Barlands

Response to queries

Amendments to kitchen extension

Kitchen extension - Materials

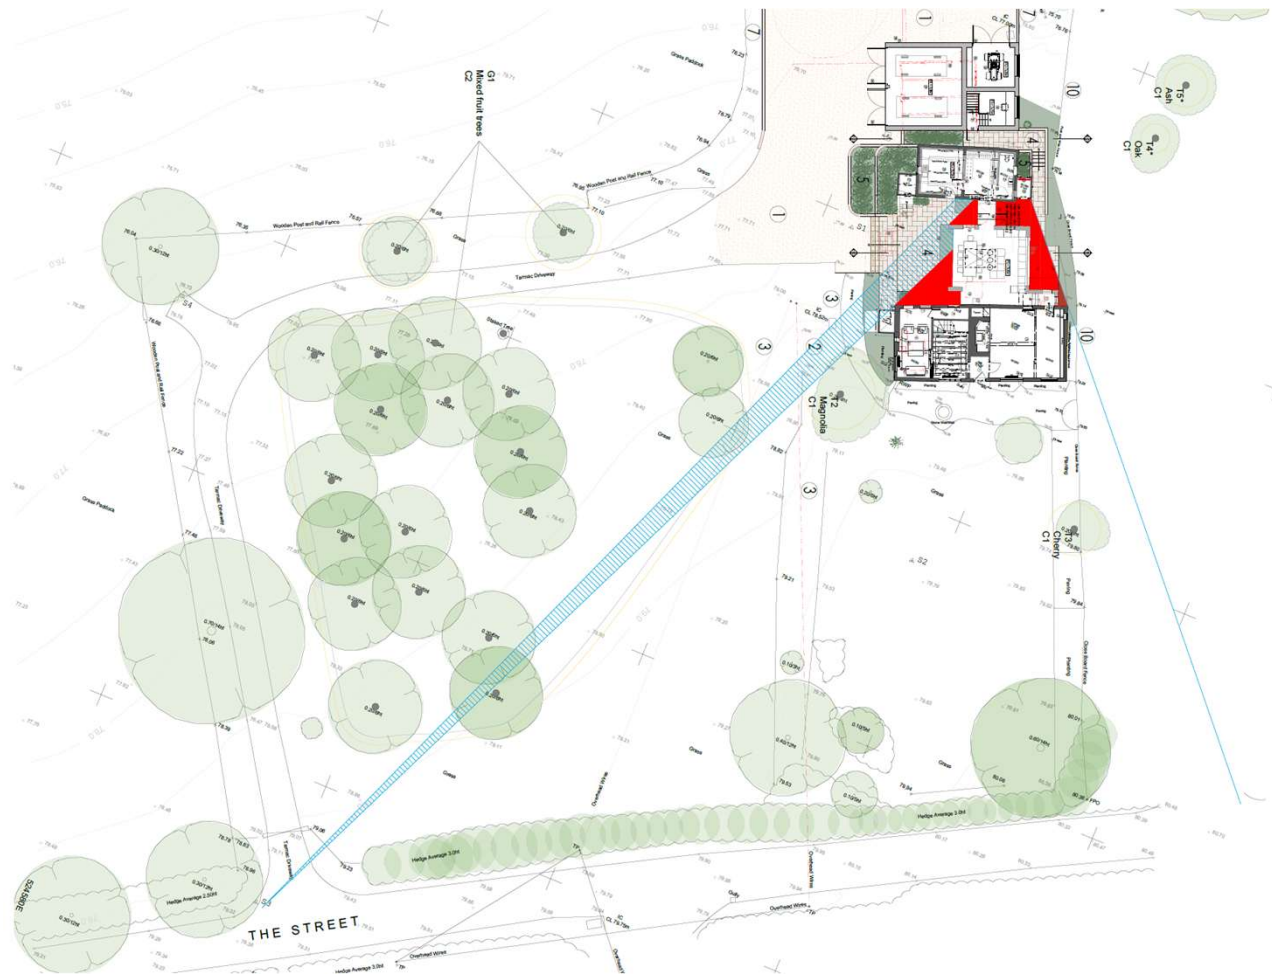
- *'It is recommended that the new work is matched to the existing in terms of fabric size, however, to take the lead from the building as it has evolved, it is worth considering a contrast in fabric to allow the alteration to remain clearly legible.'*
- In response to this point from Maggie regarding the materials, we note the appearance of the barn immediately to the east of Barlands, which would have once formed a part of its curtilage, see below:

- You will note that the building uses stone to its flank walls, with facing brick to the lower part of its north-facing wall. The north-facing gable is then treated with featheredge timber boards with a dark stain. As this building would once have formed a part of its curtilage, and will be visible through the clerestory glazing to the Kitchen link extension, it is suggested that to adopt its vernacular for the increased height would be appropriate. Much has been made of the relationship between Barlands and its adjacent former farmstead, so we would deem this to be an appropriate, and acceptable, solution.
